To: Honorable Mayor Patrick Collins and Members of the City Council
From: Connor White, Planner II
Subject: PUDC-24-107 / Scenic Development, 5th Filing / Final Plat
Date: September 9, 2024

To: Planning Commission Members
From: Connor White, Planner II
Subject: PUDC-24-107 / Scenic Development, 5th Filing / Expedited Plat
Date: September 3, 2024

FILE: PUDC-24-107: Scenic Development, 5th Filing (Expedited Review)

SCENIC DEVELOPMENT, 5TH FILING

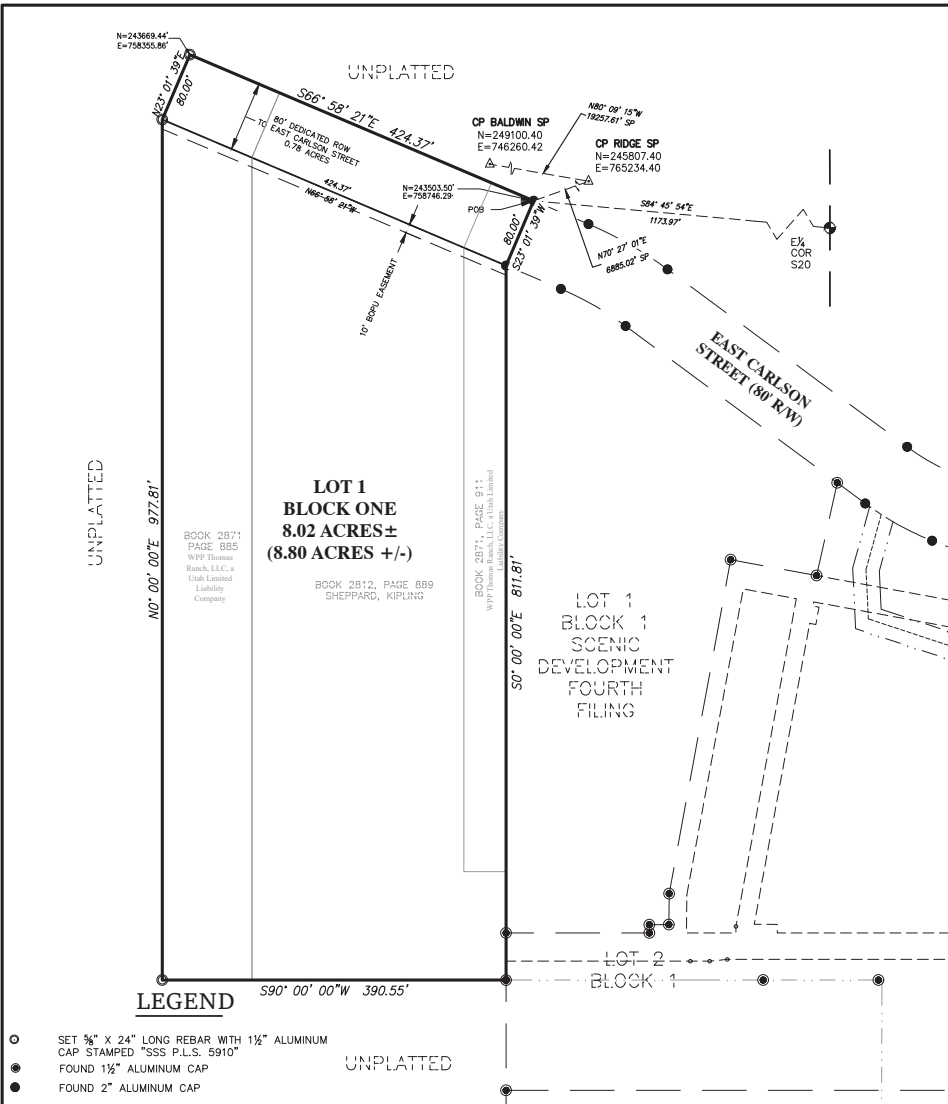
1. Exception to block size.
2. Conditions:
 - a. Correct the dedication for names and formatting on the plat.
 - b. Dedicate the existing street adjacent to this development as shown in the current configuration of Connect 2045 or submit an update to Connect 2045 to reflect the changes in the street network for Section 20 as proposed.
 - c. Provide a pedestrian easement along the east side of the plat.

1. Exception:
 - a. Exception to block size.
2. Conditions:
 - a. Provide BOPU easements over any facilities requiring them, to the satisfaction of the BOPU.
 - b. Correct the dedication for names and formatting.
 - c. Plat the existing streets adjacent to this development as shown in the current configuration of Connect 2045 or submit an update to Connect 2045 to reflect the changes in the street network for Section 20 as proposed.

The current block is excessively sized compared to regulations for the area. Even if a street were located on the edge of this development heading to the closest possible connection point to the south, the block perimeter would be over 2 miles in length, more than 3 times the maximum allowed by the UDC. Due to these existing conditions, an exception to block size is recommended.

This plat appears to be able to provide all required utilities to the lot within this development. Easements are not provided for BOPU utilities, these easements need to be provided to the satisfaction of the BOPU. Easements are provided to other utilities.

1. Exception:
 - a. Exception to block size.
2. Prior to approval:
 - a. Provide BOPU easements over any facilities requiring them, to the satisfaction of the BOPU.
3. Prior to recording:
 - a. Correct the dedication for names and formatting.
 - b. Connect 2045 be updated to reflect the changes in the street network for Section 20.
